February 12, 1944

**NORTH AMERICAN—REWORK OF TAIL WHEEL IDLER CAMSHAFT
DECLUTCHING CABLE—P-51A AND P-51C**

2. The instructions for accomplishing this rework as contained in North American Service Bulletin 73-84 are as follows:

Figure 1 - View Showing Roller Added and Flange To Be Removed From Idler Camshaft

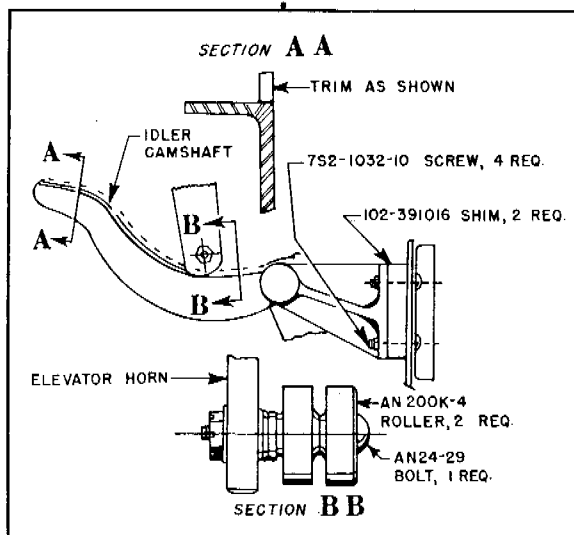
1. To prevent the possibility of the elevator controls becoming jammed due to the elevator horn assembly slipping off the declutching camshaft assembly the P-51 airplanes listed below will be reworked in accordance with the instructions contained in paragraph 2.

(1) Installation of a block between the camshaft support assembly and the fuselage frame assembly.

(2) Removal of the upper flange on the camshaft assembly.

(3) Installation of an additional ball-bearing roller on the horn assembly.

(4) File or grind the upper vertical flange off the camshaft. (See figure 1, detail AA.)

(5) Remove the bolt which secures the ball-bearing roller to the horn assembly. (This roller rides on camshaft.) Add one new roller, part No. AN200K-4, to the present assembly and secure with one new bolt, part No. AN24-29, using the same nut and washer removed. (See figure 1, detail BB.)

(6) Reinstall the two supporting brackets, inserting one each new block, part No. 102-341016, to act as a shim between each bracket and the fuselage frame. Secure with four new screws, part No. 7S2-1032-18, using the same nuts previously removed. (See figure 1.)

Figure 2
Tail Wheel Installation

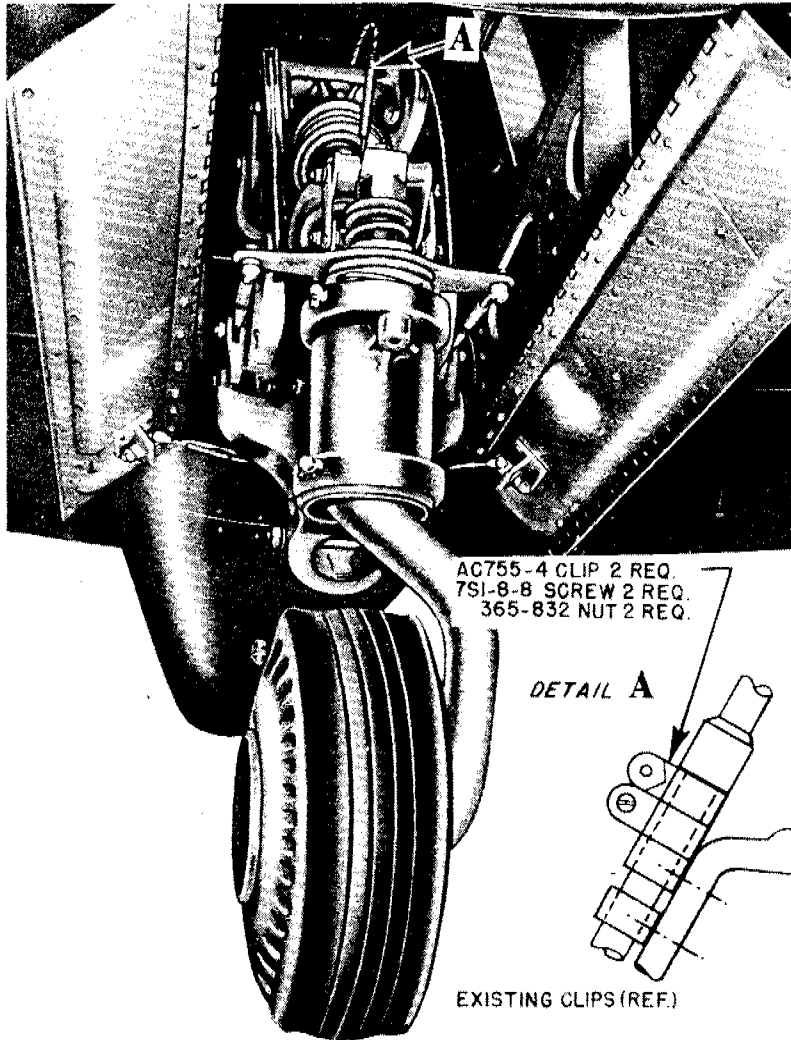
(4) Attaching two additional clips to the tail wheel declutching cable assembly.

(7) Reaching up through the fairing doors for the tail wheel, install two new clips, part No. 755-4, on the casing of the control cable which actuates the declutching mechanism for the steerable tail wheel. (See figure 2.) The clips will be installed immediately above the existing clips and below the flanged edge of the casing for the cable. Secure the clips with one each screw, part No. 7S1-8-8, and nut, part No. 365-832.
